Re: AutoZone  
98 River Road  
HEC #2135

Harry E. Cole & Son (HEC) has reviewed your checklist dated October 11, 2021 and offers this formal response

Re: AutoZone  
98 River Road, Lisbon CT TEI Job #21115  
HEC #2135

Harry E. Cole & Son (HEC) has reviewed your checklist dated September 17, 2021 and offers this formal response.

NEW LONDON COUNTY, CONNECTICUT - SHEET NUMBER 21

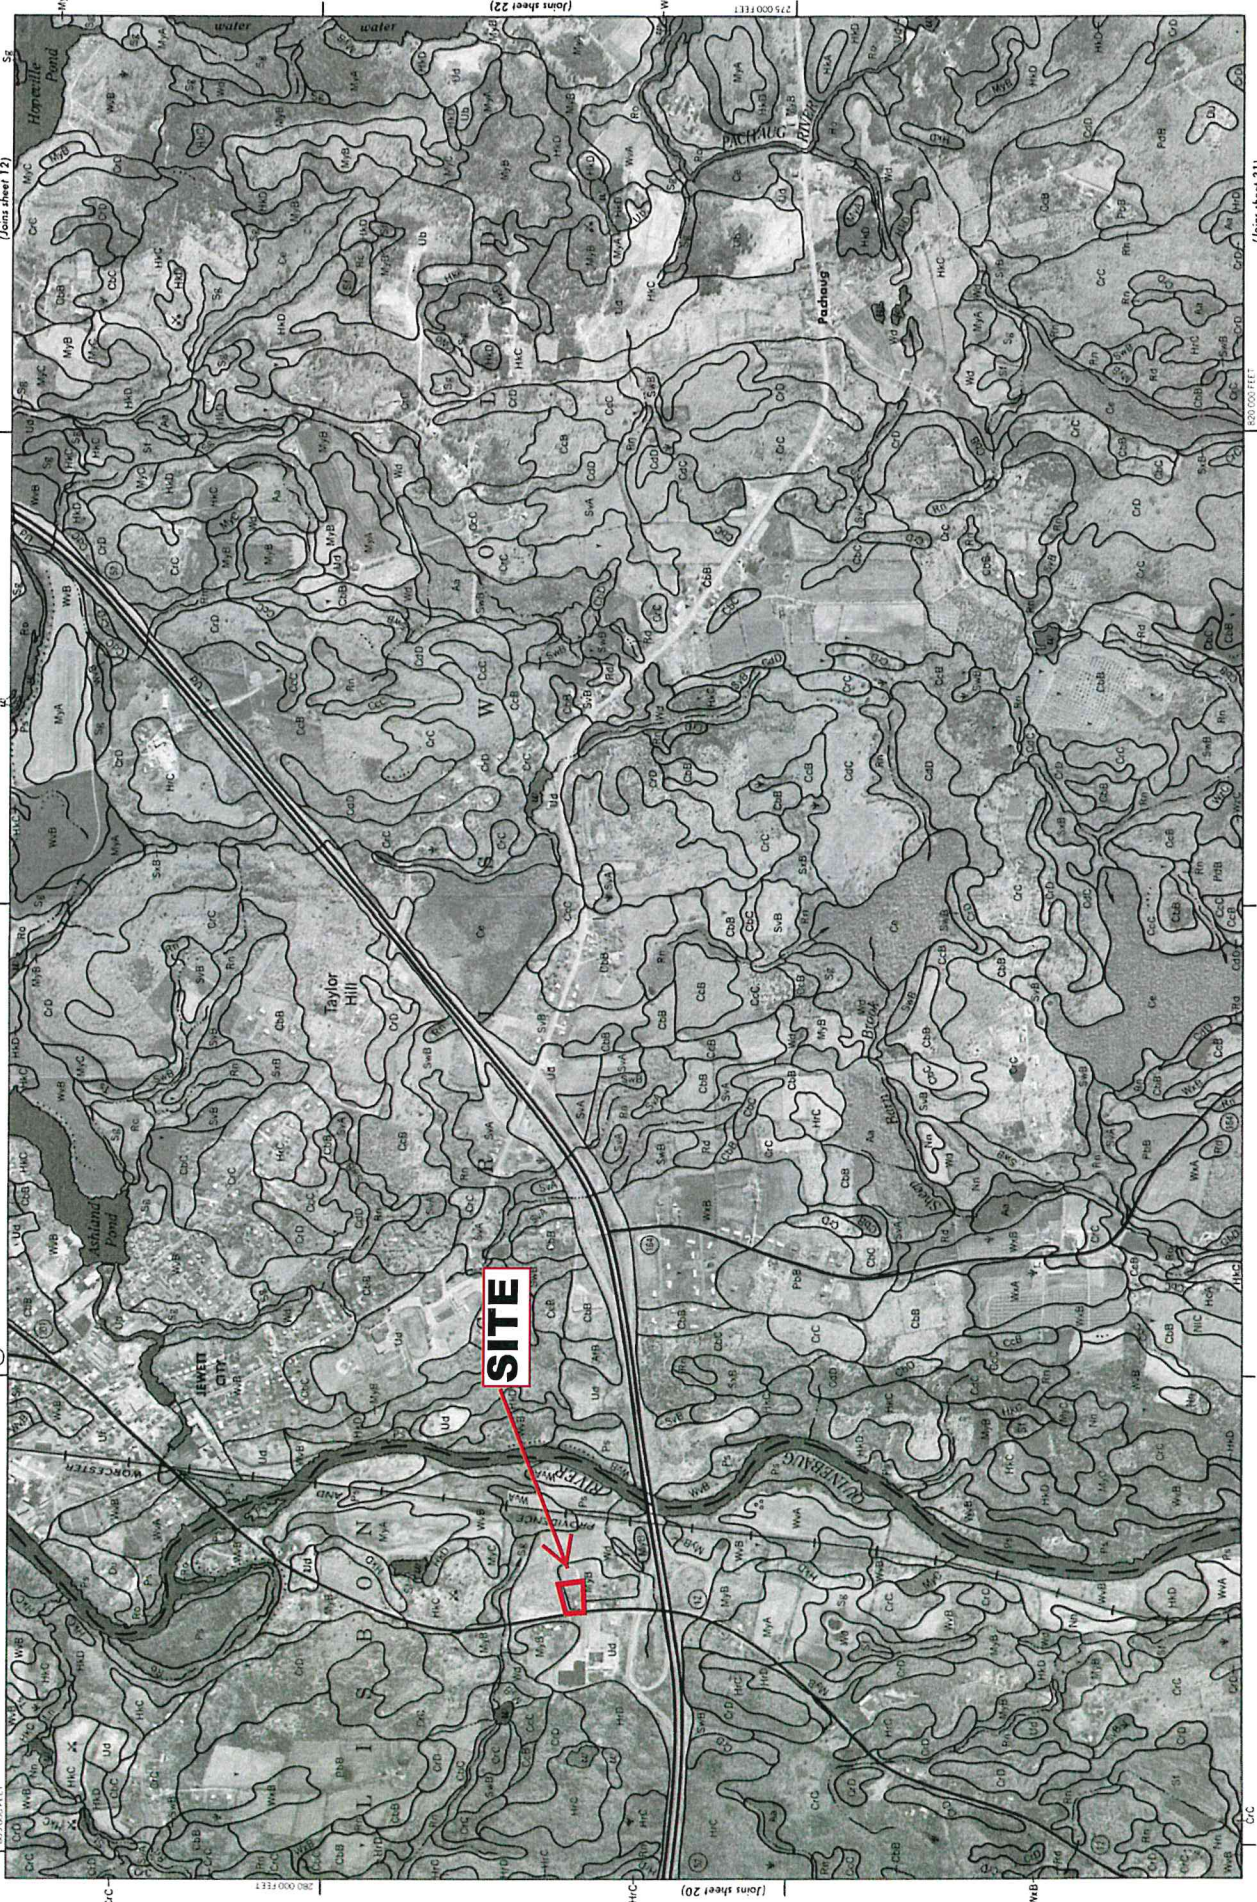
7. The E & S control plan will need to conform to recent amendments in effect as of 9/1/21. See section 10.16, available on the Town's website. Specifically, 10.16.1 addresses plan detail requirements. The New London County Soil Survey should also be cited and referenced to confirm accuracy versus only the web soil survey. There should be a sheet or two to address all the requirements.

**Response: Using the New London Soil Survey, Map 21, we have verified the MyB (Merrimac) and Ud (Udorthents) soil types on site. Revisions have been made to the E&S sheet (C1.B) and the detail sheet (C1.5) in accordance with these regulations. Sheet C1.B has been revised and has a detailed narrative and details for Erosion Control Measures.**
